**Subject: Mitsubishi Fuso Truck & Bus Corporation Foreign Recall Notification
(Substantially Similar Vehicle)**

On December 8, 2016 Mitsubishi Fuso Truck & Bus Corporation (MFTBC), Japan advised Mitsubishi Fuso Truck of America, Inc. (MFTA) that MFTBC has decided to conduct a Recall Campaign in foreign countries involving vehicles that are substantially similar to vehicles offered for sale in the United States. Please see the details of the recall campaign below:

Defect Description

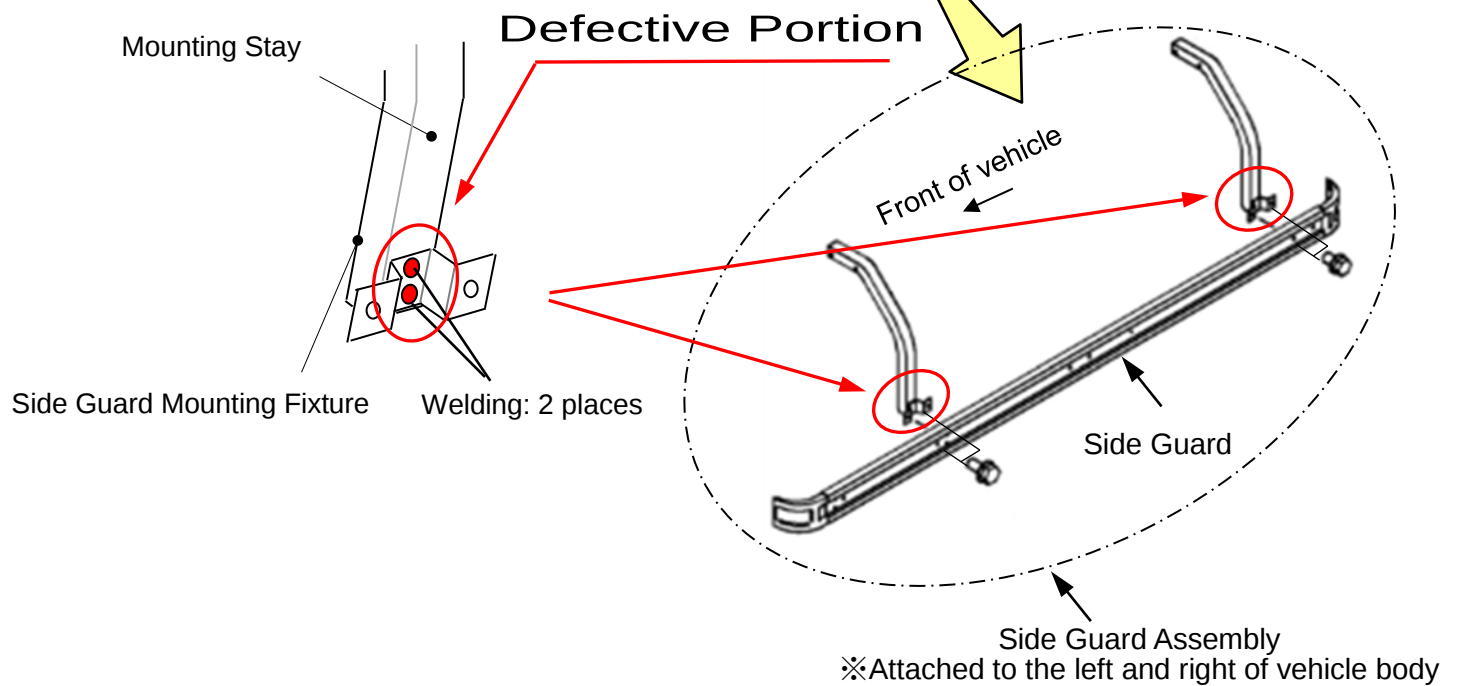
On affected vehicles equipped with side guards, the side guard mounting fixture and stay are not properly welded. The welded portion may separate and the side guard may come off the stay. In the worst case, the side guard may fall off of the vehicle while driving.

On all affected vehicles, the side guard mounting stays will be replaced with improved components.
